Flight Procedures Cover Page	Task Action: FLIGHT CHECK	Task Type: IAP	Estimated Chart Date: 03/19/2026	APWS Task ID: 4114EE917B43426797FD1C4C3B4A5B80	APWS Project ID: 4565656BD4C94F4DAB88629B701AD00E
Procedure: RNAV (GPS) Y RWY 13L AMDT 2		Enroute: NO	Specialist: Young, Silvia		Agreement Number:
Airport ID: KDAL			Airport City: DALLAS		State: TX
Facility ID:	Facility Type:	Flight Inspection Remark Type: New FC Slot

RNAV (GPS) Y RWY 13L DALLAS LOVE FLD (DAL)

Subject: Letter of Approval Request KDAL RNAV (GPS) RWY 13L

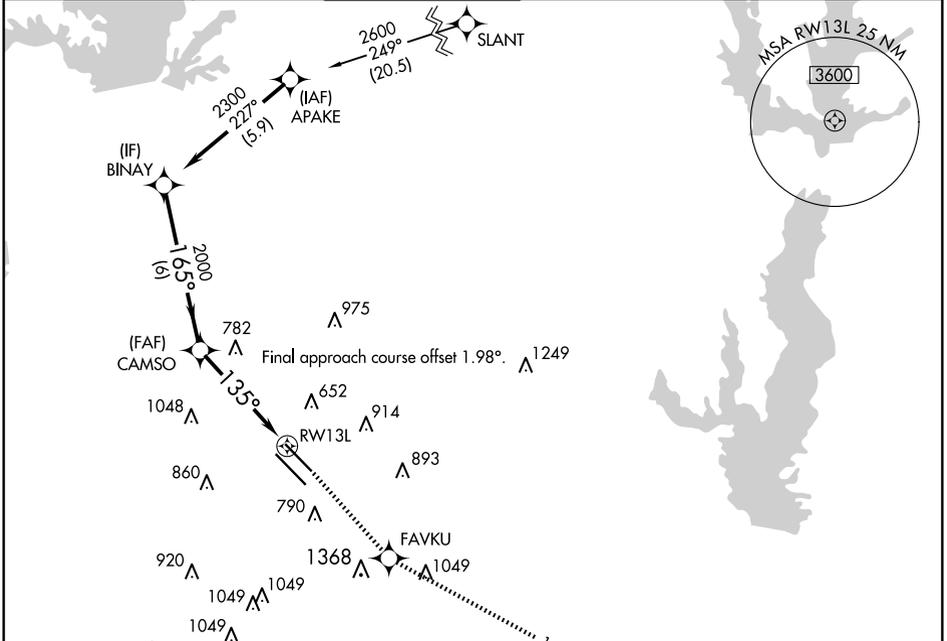
APPROVAL LETTER: 1. MANDATORY ALTITUDE AT WENOP.

KDAL RNAV GPS RWY 13L: WENOP Mandatory Altitude.

Lonestar (D10) TRACON requests AFS approval to chart a mandatory altitude restriction at the following fix: WENOP at 3000ft MSL for RNAV GPS RWY 13L instrument approach procedure for Dallas-Love Field (KDAL).

Currently, FAAO 8260.19K paragraph 8-6-11n (1) requires Flight Standards approval from the Flight Technologies and Procedures Division to chart a mandatory altitude on the intermediate segment of an instrument approach procedure.

Therefore, Lonestar TRACON requests to chart the mandatory restriction at WENOP RNAV GPS RWY 13L. This is an ATC operational request to ensure vertical separation between aircraft on the approach and other traffic.
